ENCLOSURE 2  
 TENNESSEE VALLEY AUTHORITY (TVA)  
 BROWNS FERRY NUCLEAR PLANT (BFN)  
 UNITS 1, 2, and 3

PROPOSED TECHNICAL SPECIFICATION (TS) CHANGE TS-353  
 MARKED PAGES

II. MARKED PAGES

Fig. 2.1-2  
1.1/2.1-7

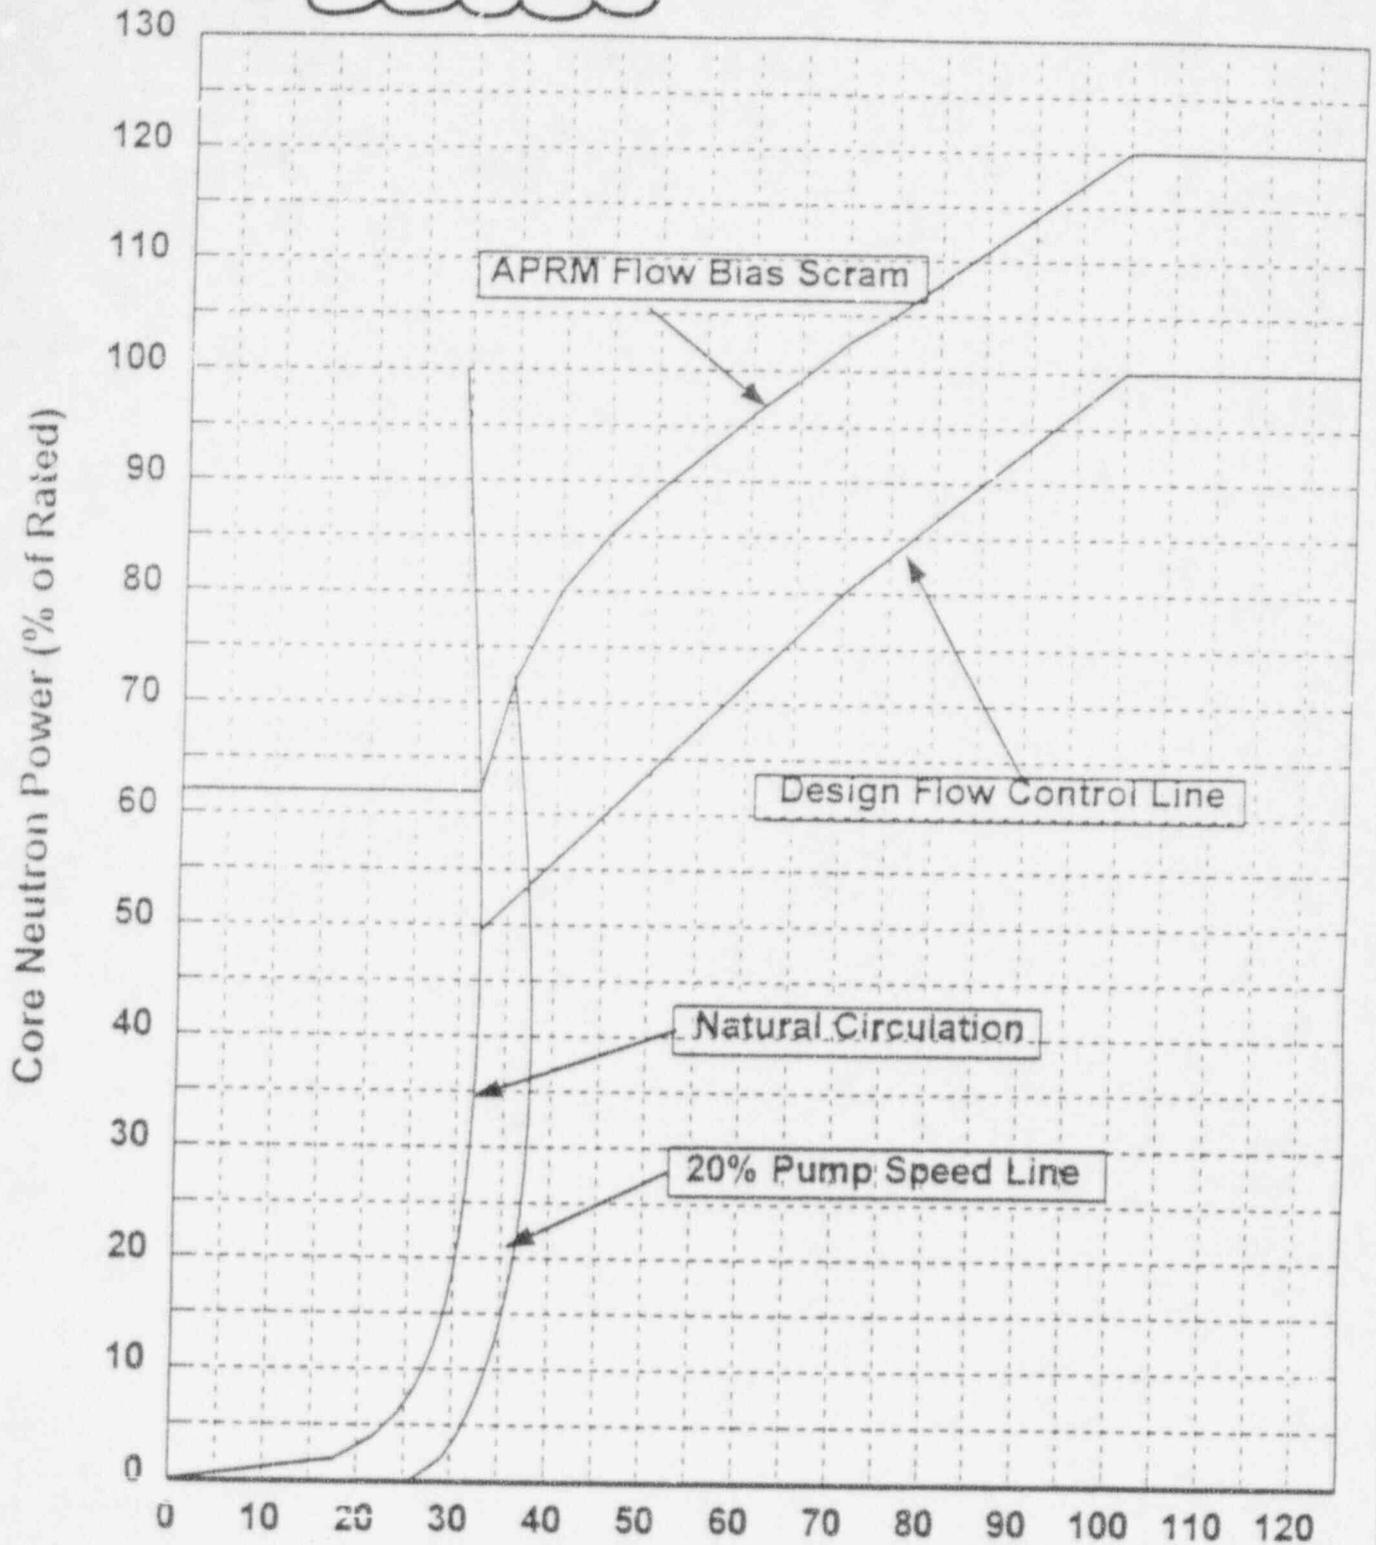
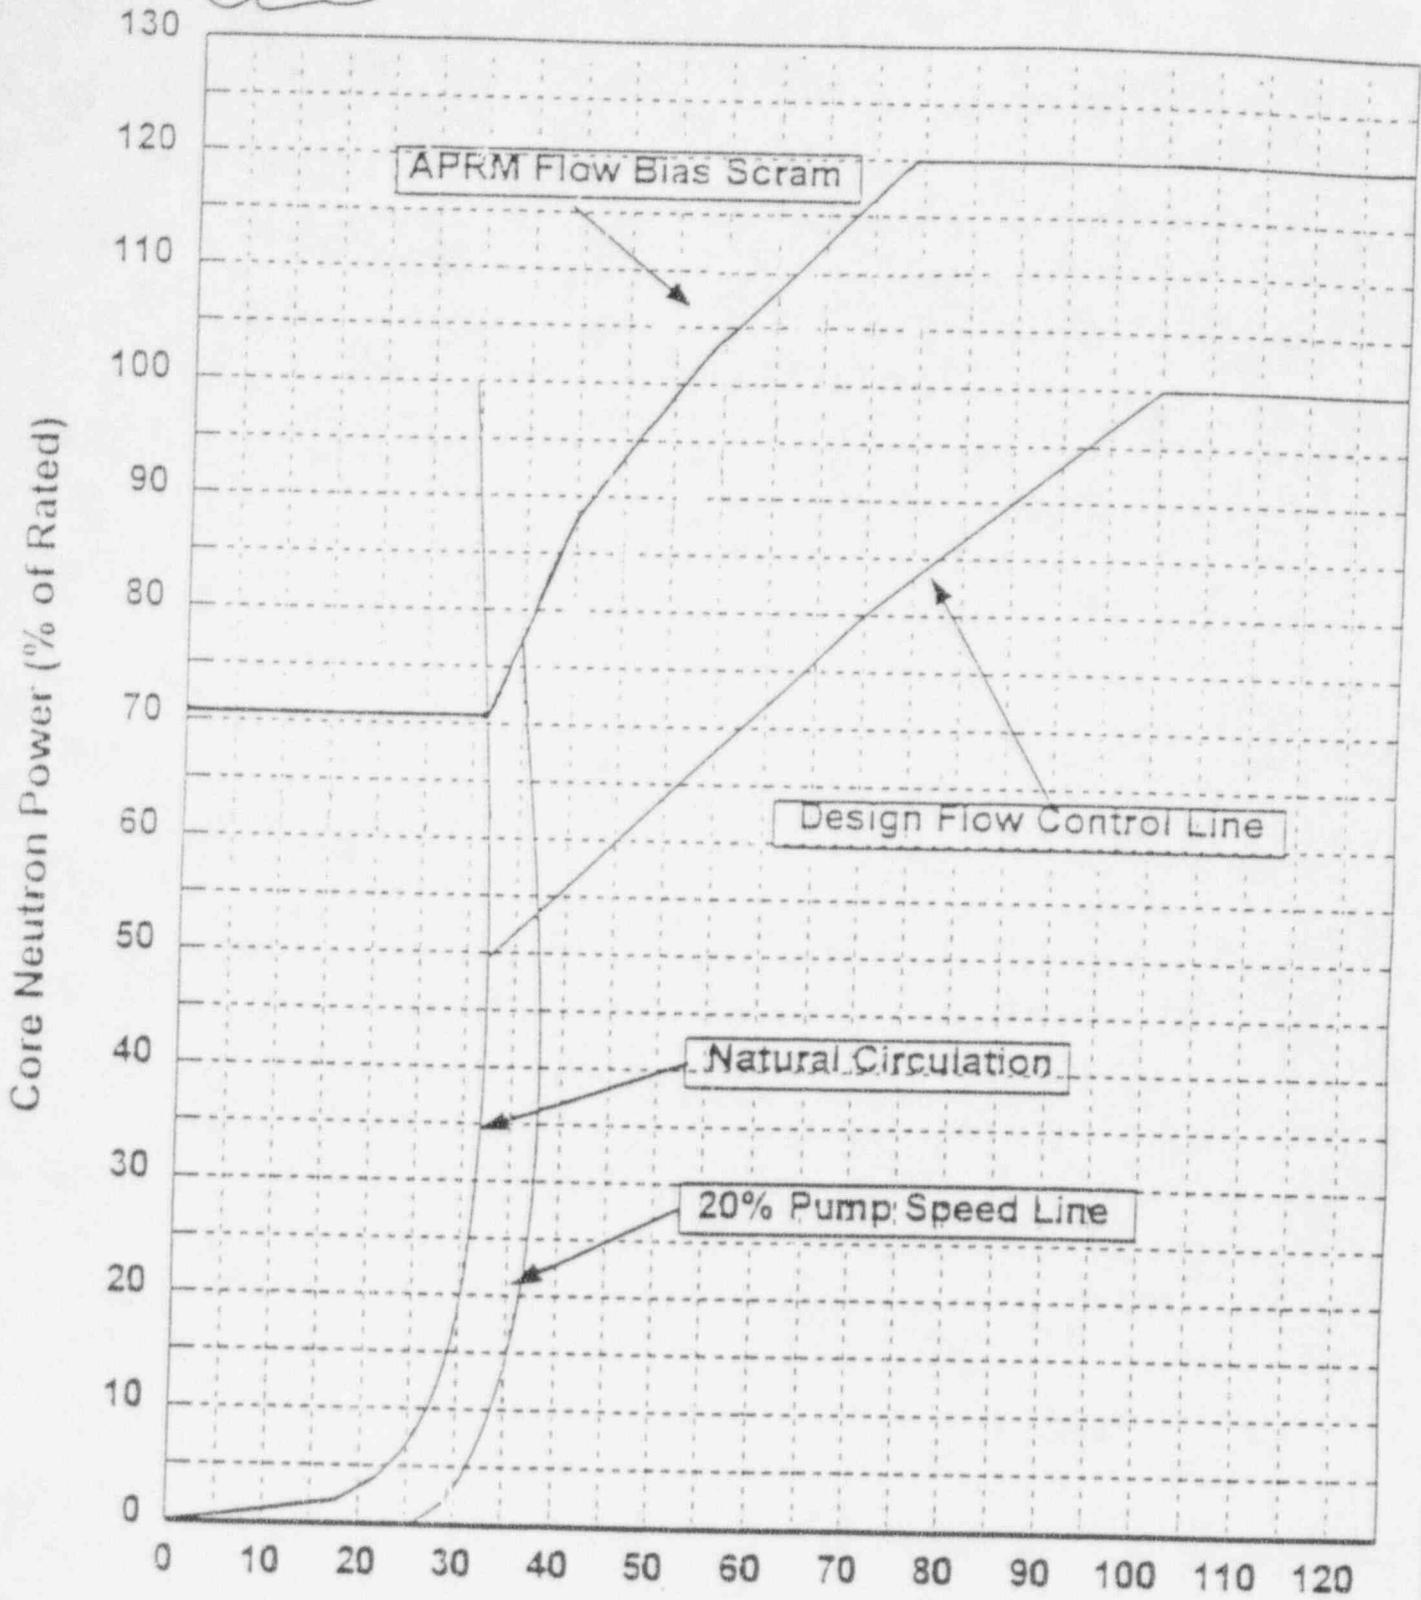
REPLACE WITH  
NEW FIGURE

New

APRM Flow Bias Scram vs. Reactor Core Flow

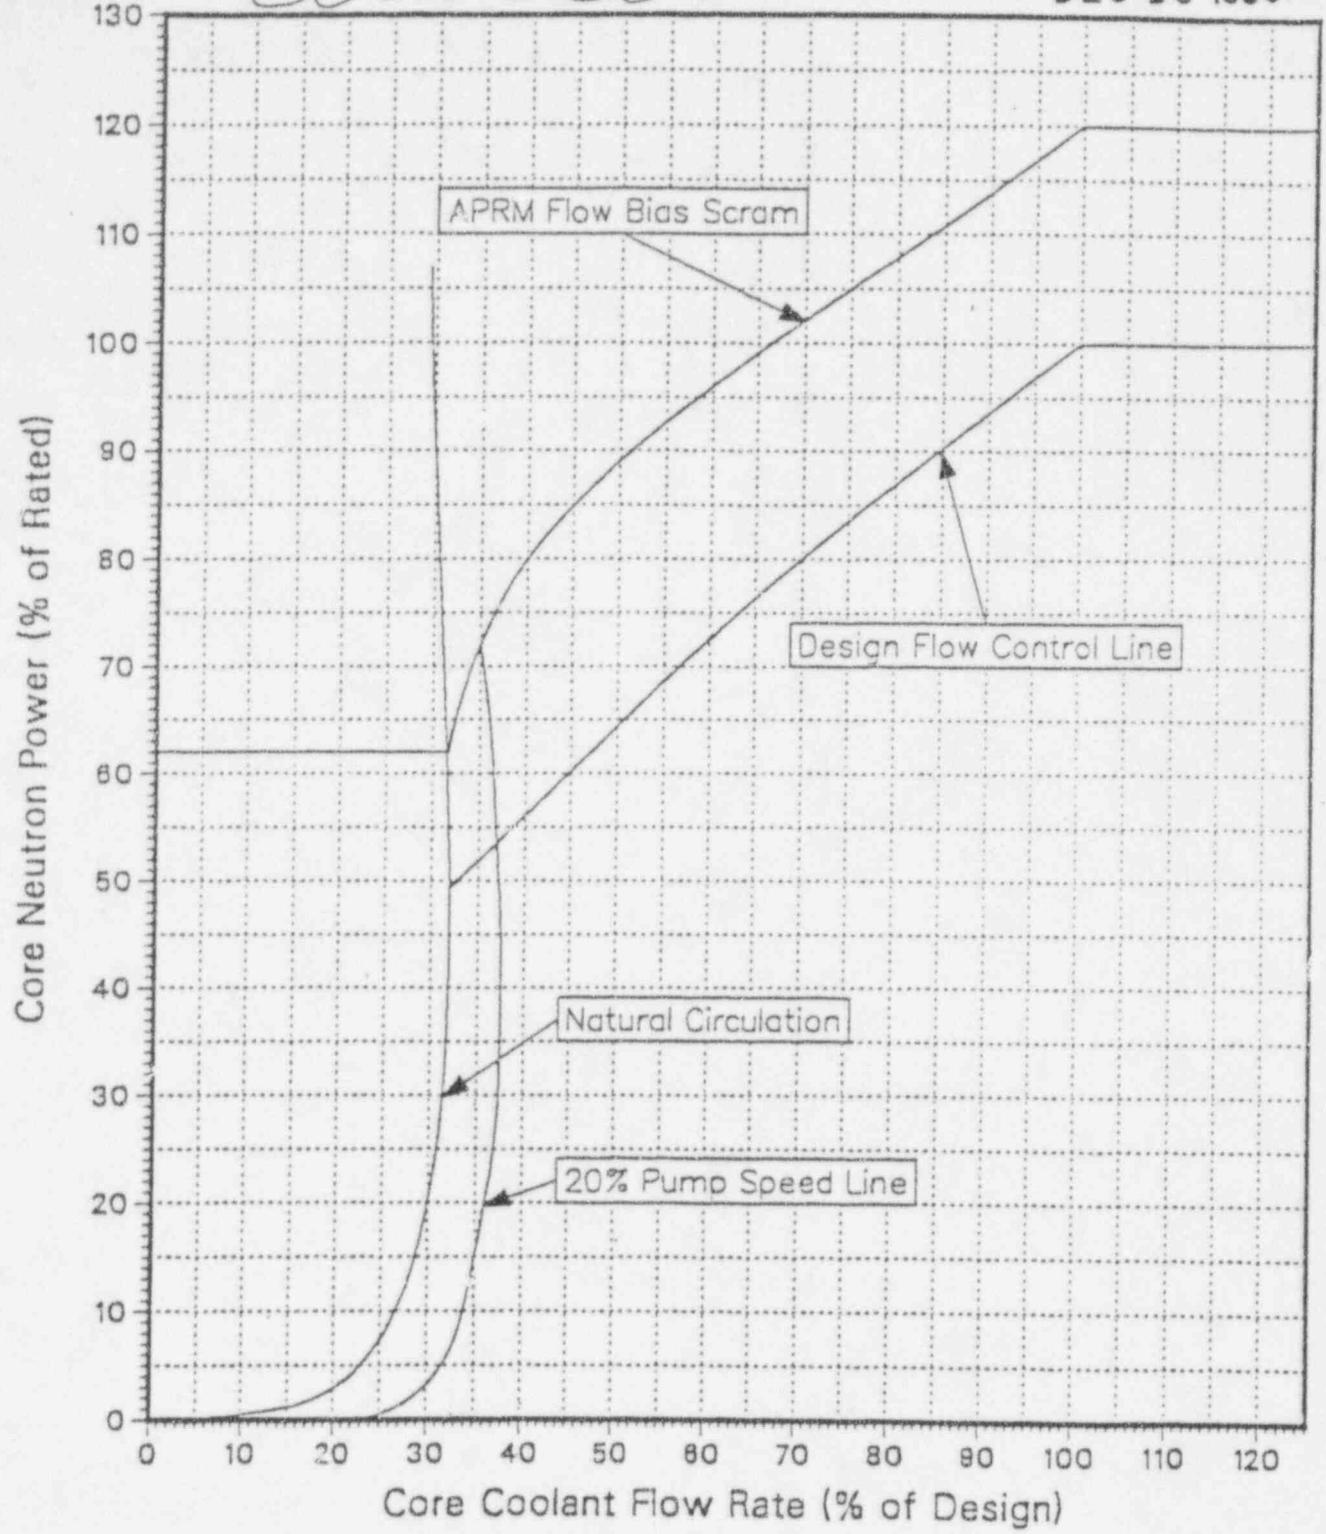
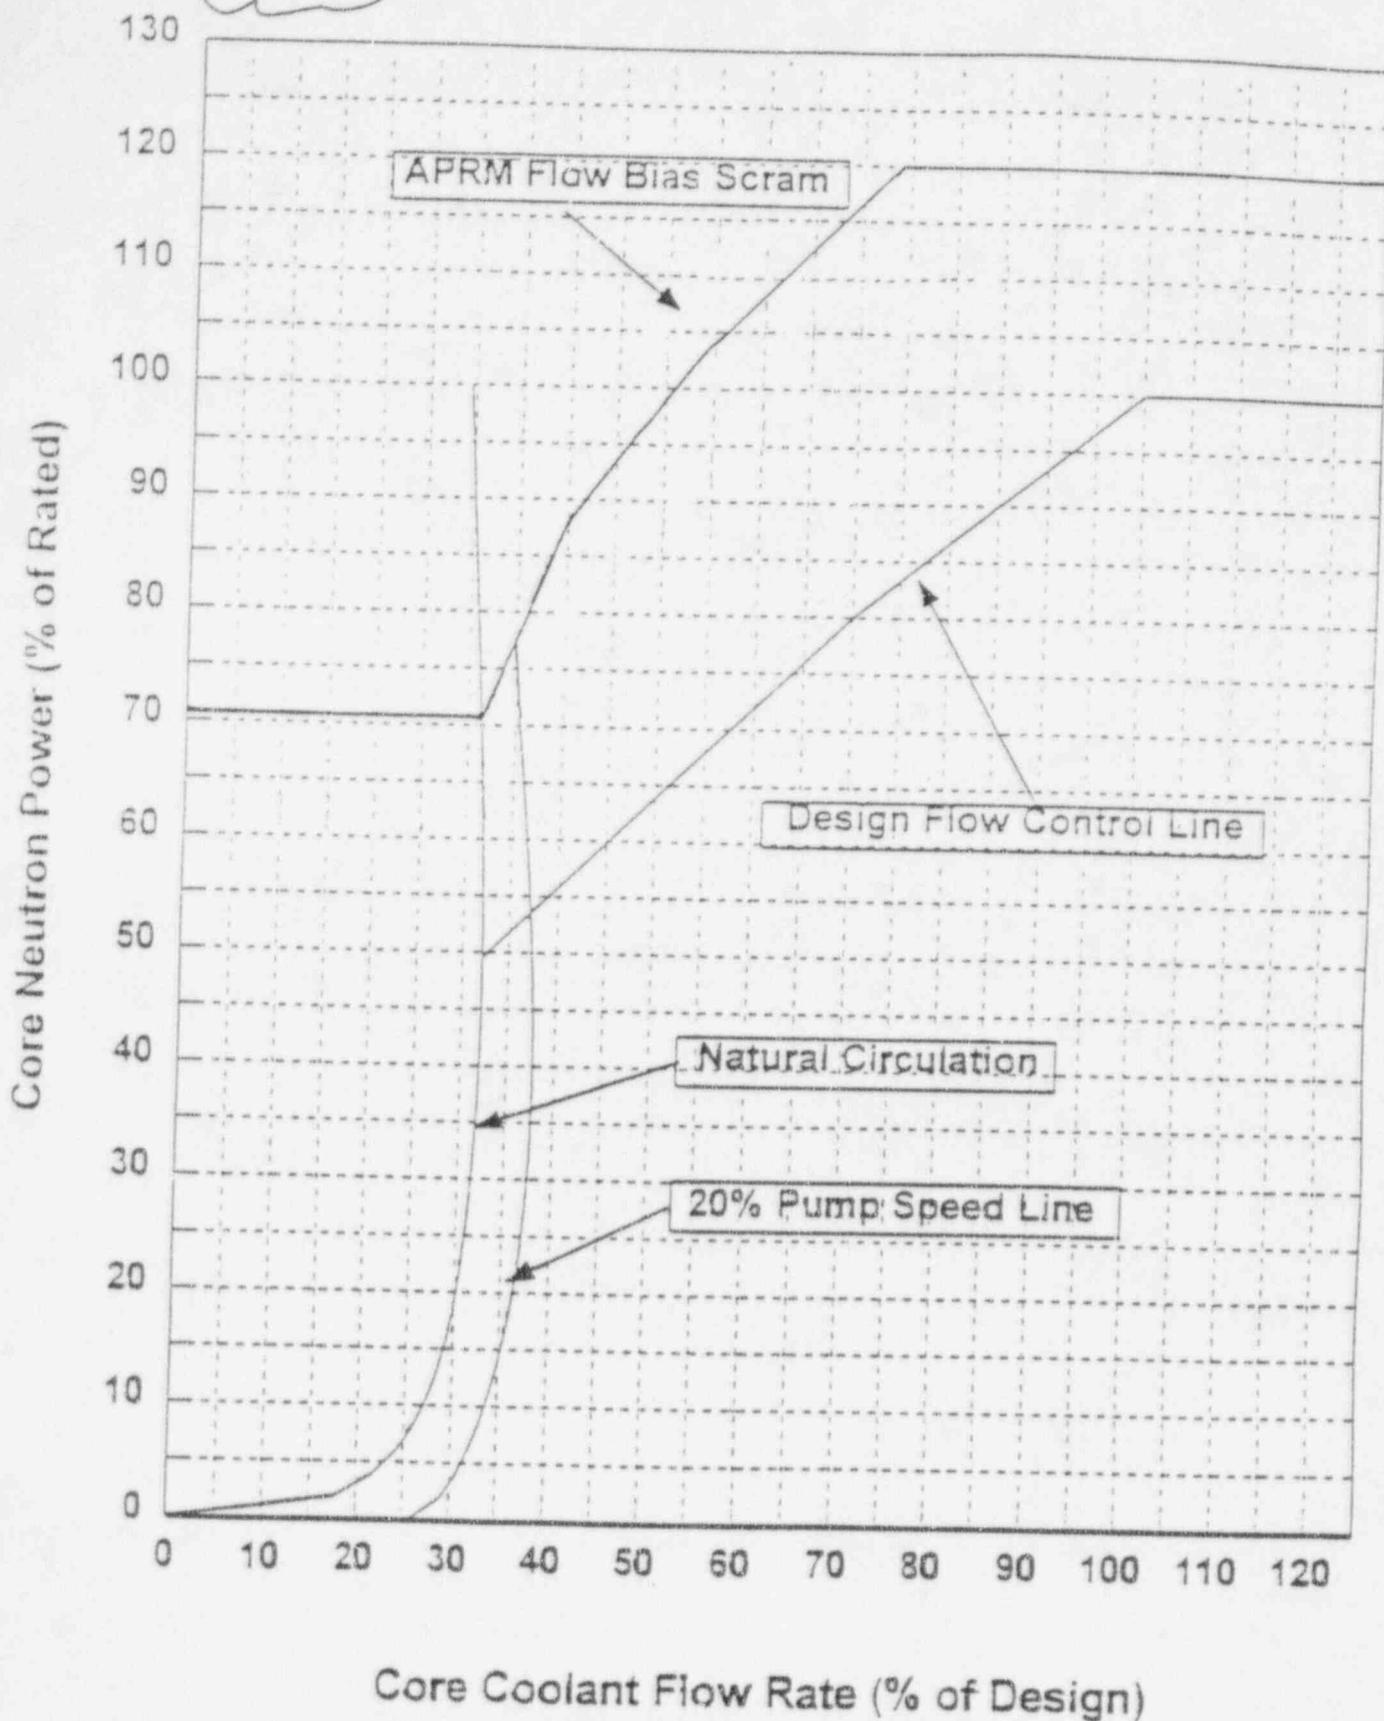
REPLACE WITH NEW FIGURE

New
